SUBJECT: Lot A – Public Hearing to Approve an Addendum to the 601 Capitol Mall Project Environmental Impact Report (EIR) and to Approve the First Implementation Agreement Amending the Disposition and Development Agreement (DDA) between the Redevelopment Agency and Lot A Landholders, LLC and David S. Taylor Interests, Inc. (DST)

COUNCIL DISTRICT AND LOCATION: Council District 1, 601 & 621 Capitol Mall

**ADDENDUM TO THE 601 CAPITOL MALL PROJECT
ENVIRONMENTAL IMPACT REPORT
621 Capitol Mall, Sacramento, California**

Figure 1-Building Section

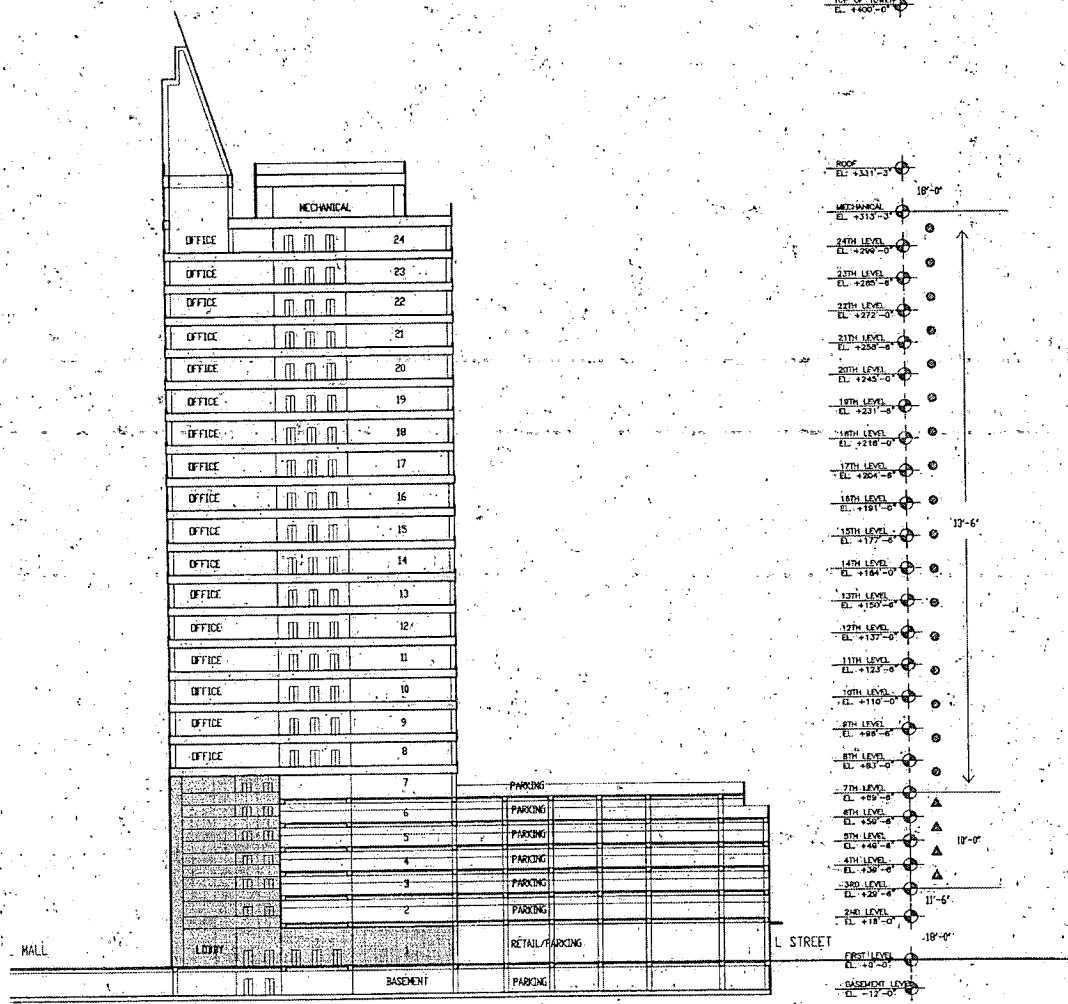
The modified project changes would flip the location of Phases I and II, and provide an additional 25' setback from Capitol Mall. The Phase I building, still 400' to the top of the architectural element but now only 24 stories, would be constructed on the east side of the site along 7th Street. The project will maintain office and retail square footages equal to or less than those identified and analyzed in the EIR. The total Phase I project as modified would be a maximum of 668,833 gsf, consisting of office (344,386 gsf), retail (13,918 gsf), restaurant (6,726 gsf), parking (698 parking spaces) and mechanical penthouse. Ingress and egress locations will remain similar, although the service entry/exit on 7th Street will be located a little closer to Capitol Mall.

The Phase I office building will be a landmark, Class A high-rise, ~~26~~24-floor office tower, up to 400 feet to the top of the architectural element, with ground floor retail and parking. The building will feature one level of subterranean parking, six levels of above grade parking on levels 2 through 7, and ~~18-16~~ levels of office space on levels 8 through ~~25-24~~ (Figures 3.0-10 to 3.0-12: Typical Floor Plans). The first or ground level of the building will feature a grand lobby with restaurant and retail tenants (Figure 3.0-13: Ground Level Plan). The figures are located at the end of this chapter.

Figure 2: Ground Level Plan

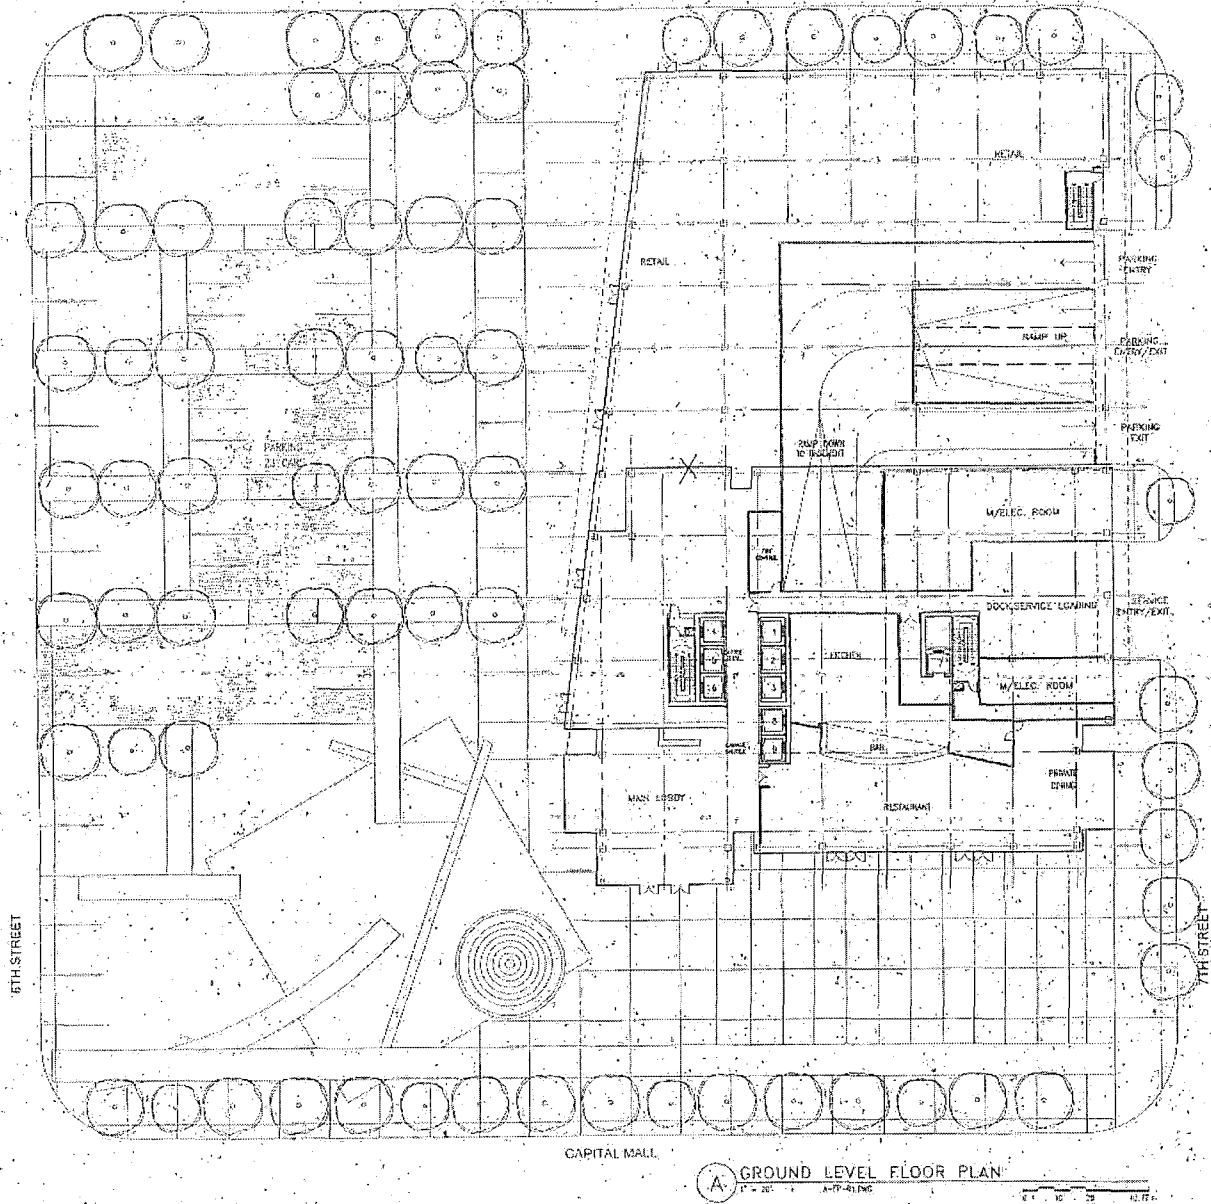
The podium of the building will be built to the property line on both the ~~6th-7th~~ Street and L Street sides of the project site. The subterranean parking includes approximately 175 spaces. Access to all parking and loading will ingress and egress on ~~6th-7th~~ Street.
